CAB,ASSY,TBL SENS SHORT, TS-A ASSEMBLY DRAWING

PART NO.	REV	DOC	SHEET	OF
10 - 3774B - A	AD	1	1

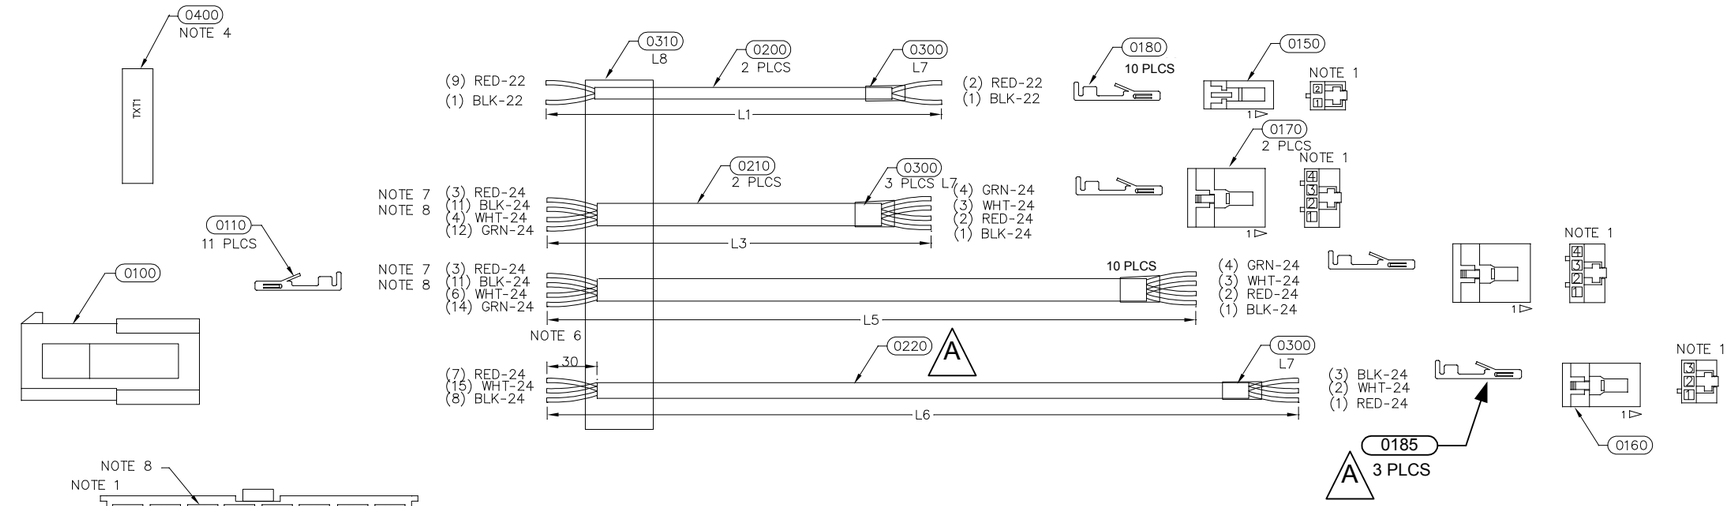
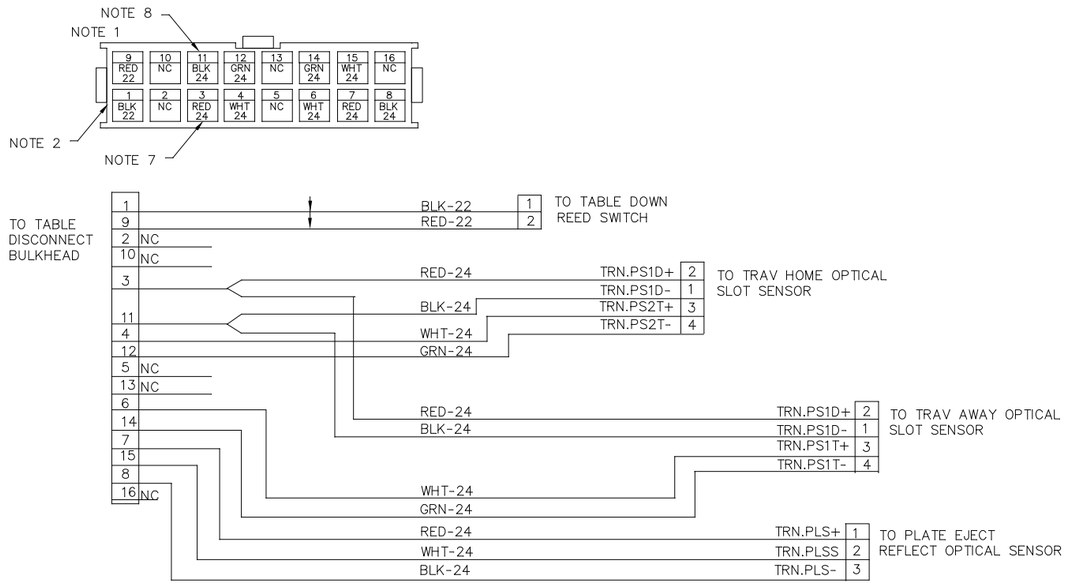
A These pins have been changed from gold to tin plating in this version and the length of L6 has changed from 1040 mm to 1190 mm.
